CORRECTION
 SERVICE FLASH

PRODUCTION CHANGE
 ADD INFORMATION

Model: **DP19647**

Effective from : Chassis No. **P19647-04**

1. IN THE CHASSIS ELECTRICAL PARTS LIST MAIN PC BOARD AND MISCELLANEOUS

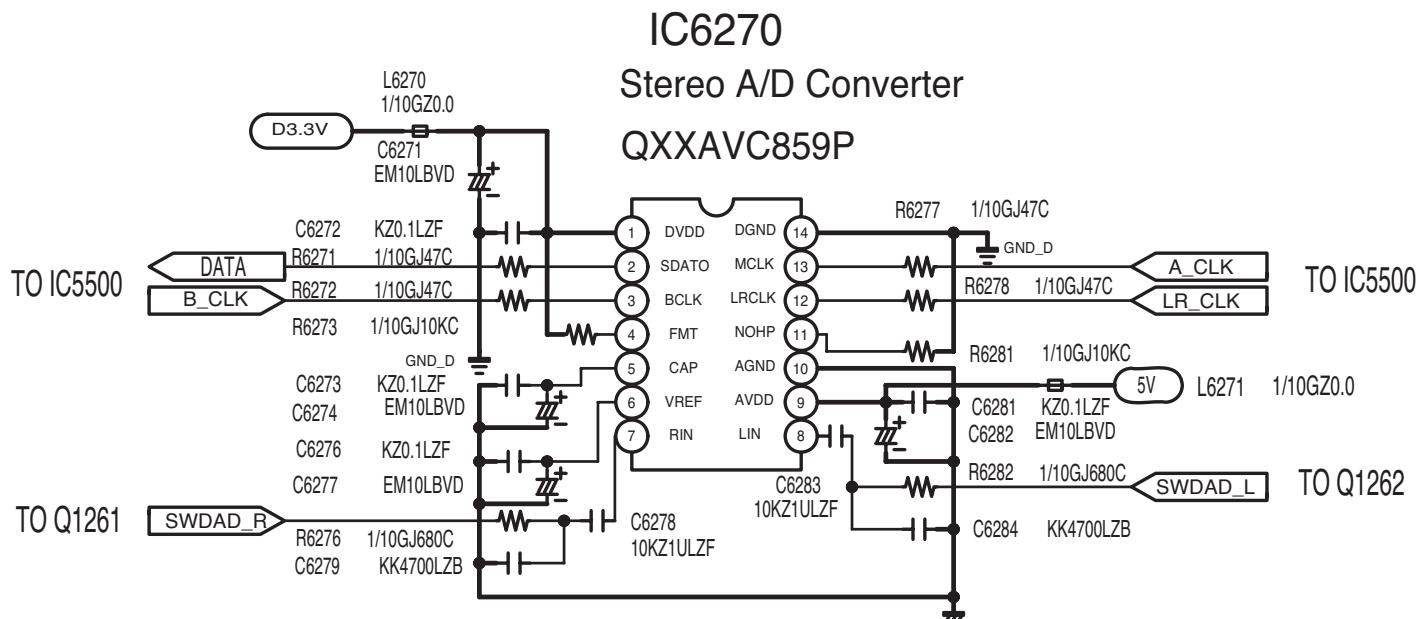
Page & Section	Schematic Location		Part No.	Description	Q'ty	Interchangeability	Reason
Page 21 Chassis Electrical Parts List	R1263	Old	RGFR000ZTCANL	MT-GLAZE 0.000 JA 1/10W	1	NO	D
		New	RGF1001JTCANL	MT-GLAZE 1K JA 1/10W	1	NO	
	R1266	Old	RGF2201JTCANL	MT-GLAZE 2.2K JA 1/10W	1	NO	D
		New	RGF1001JTCANL	MT-GLAZE 1K JA 1/10W	1	NO	
	R1269	Old	RGFR000ZTCANL	MT-GLAZE 0.000 JA 1/10W	1	NO	D
		New	RGF1001JTCANL	MT-GLAZE1K JA 1/10W	1	NO	
	R1271	Old	RGF2201JTCANL	MT-GLAZE 2.2K JA 1/10W	1	NO	D
		New	RGF1001JTCANL	MT-GLAZE 1K JA 1/10W	1	NO
